NOTICE OF ERROR
REPLY

Water right number: 37-2623

Re: Notice of Error-Water Rights Valley Club Inc.
37-2623, 37-494, 37-657B, 37-495, 37-833K, 37-0577BU, 37-057BV

VALLEY CLUB II
2006 Irrigation calculation
NAIP 2006 Aerial photo

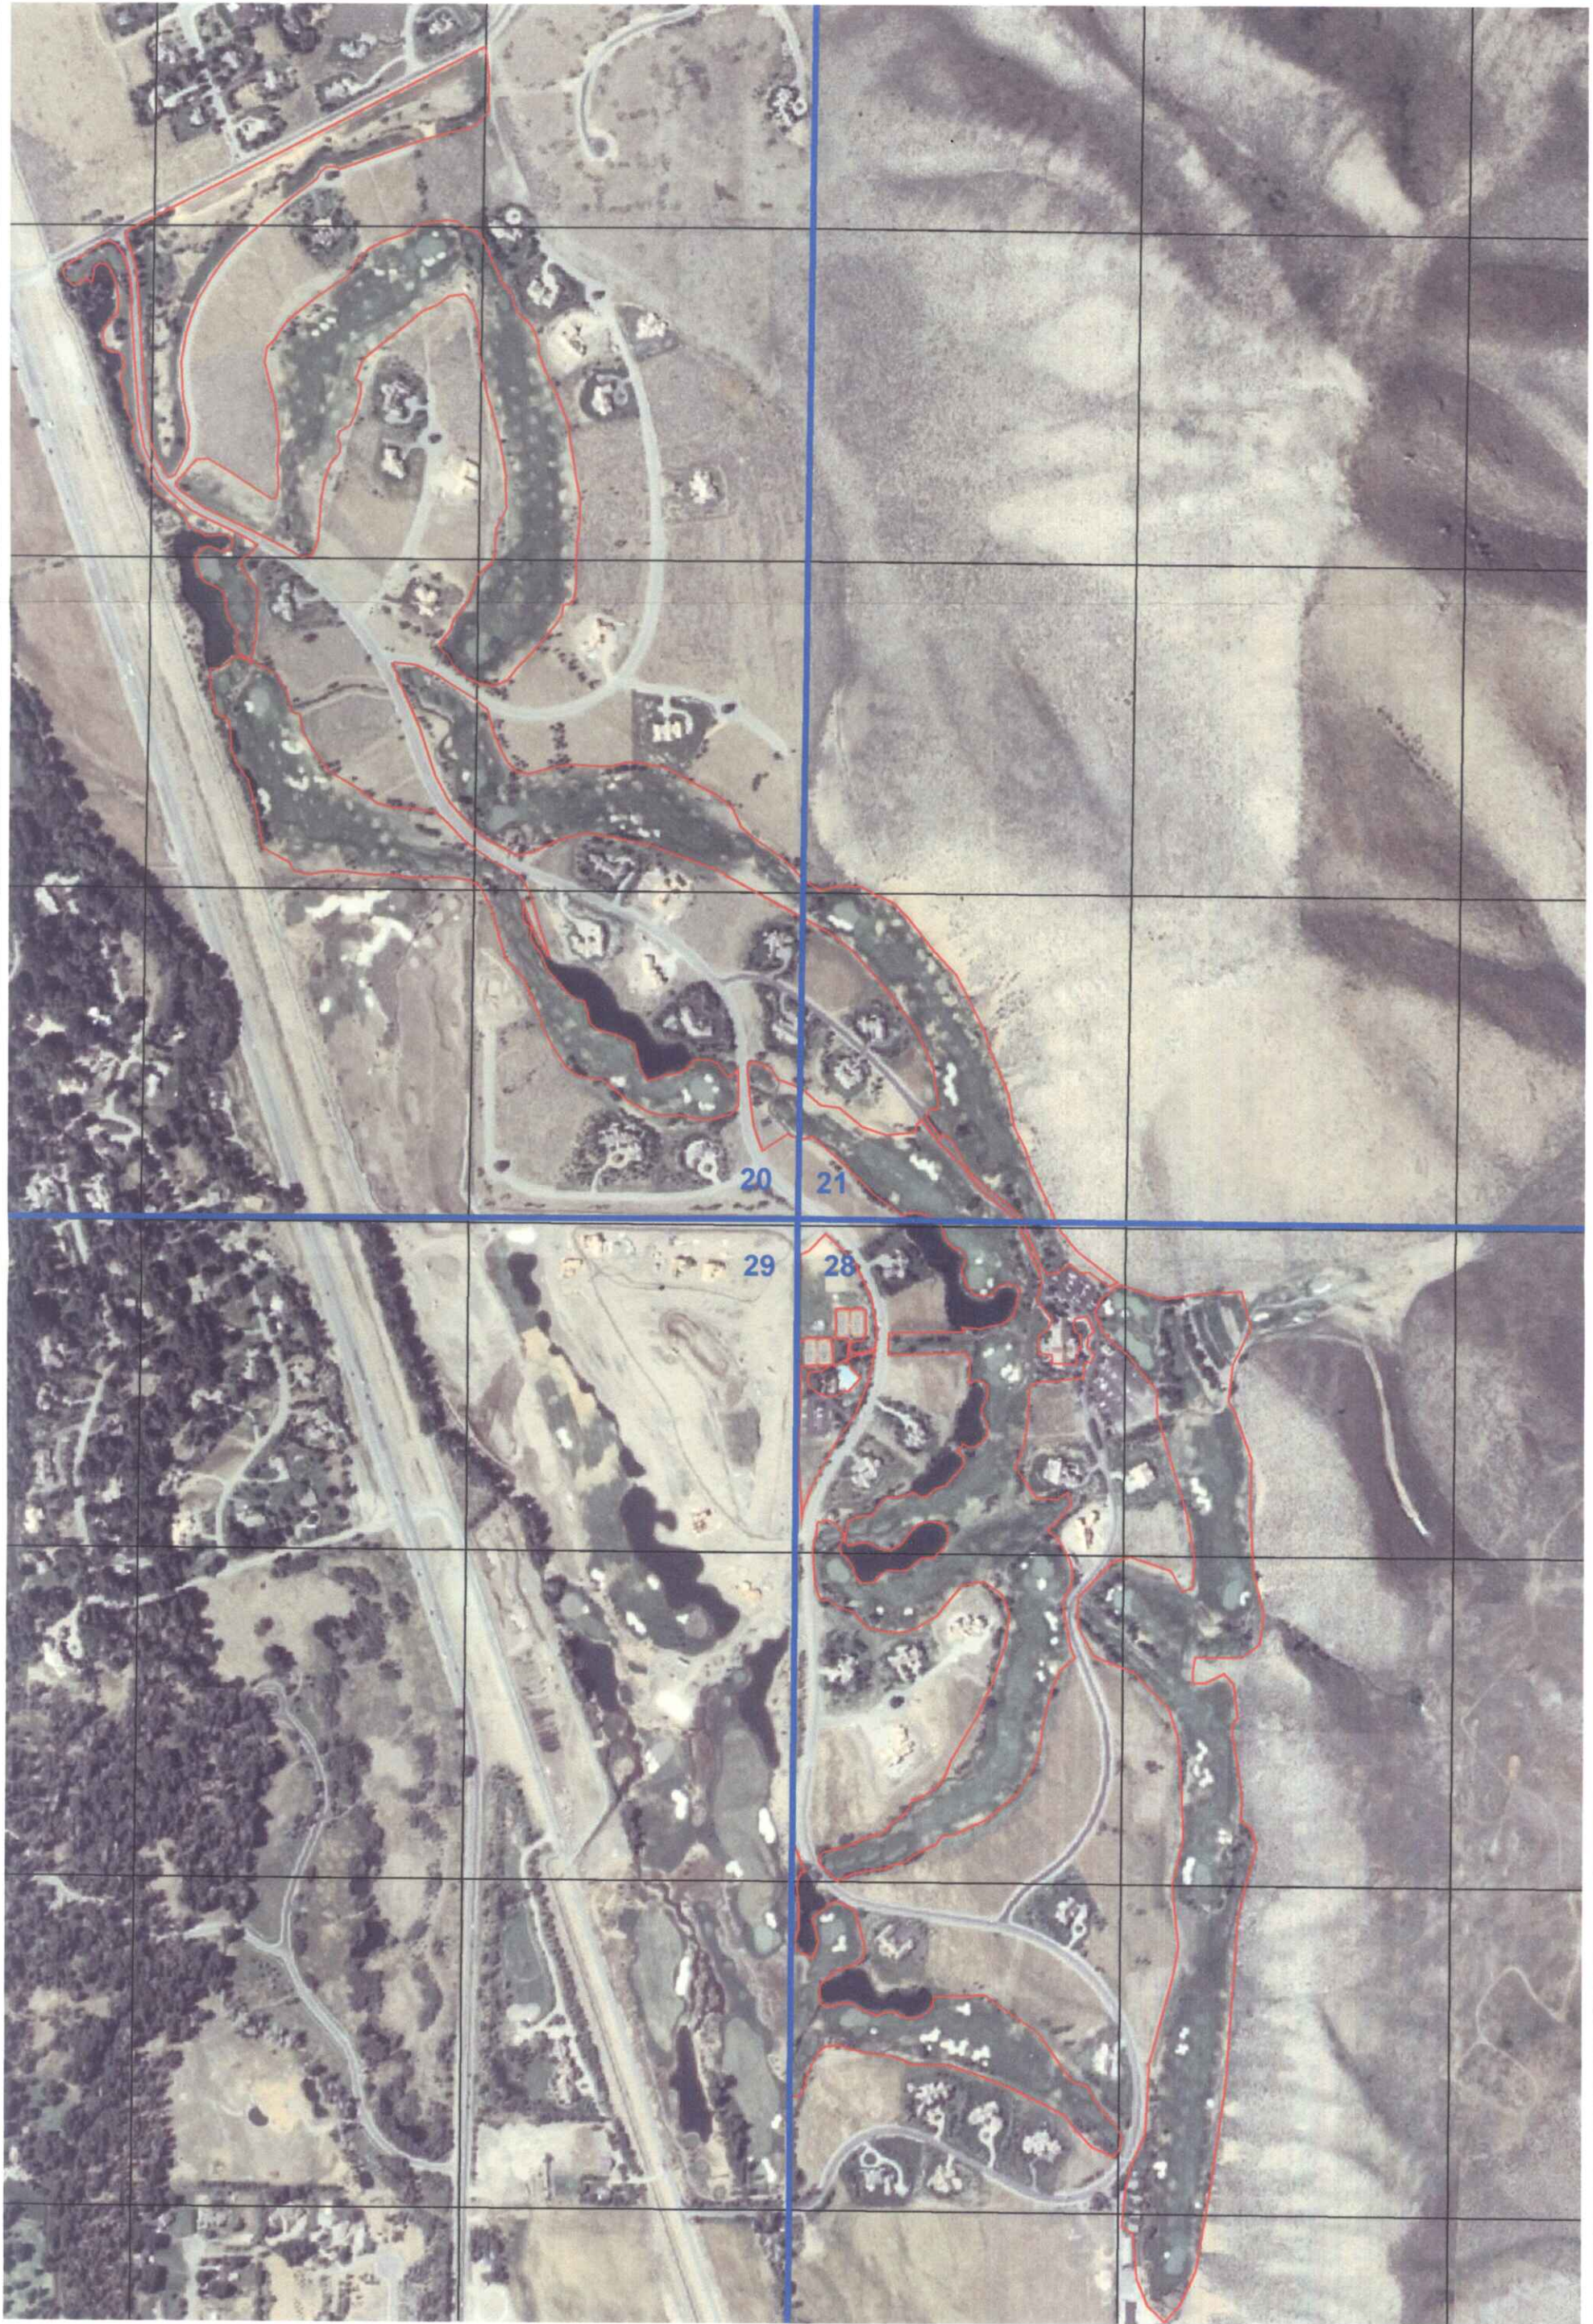
Acreage recommended is 120.7 acres

*Change To 143.8 - See Brockway Engineering
.shp file and spreadsheet*

IDWR .shp file is incorrect

Sum = 144.6 acres
Claim = 143.8 acres
Pre. Rec.= 120.7 acres
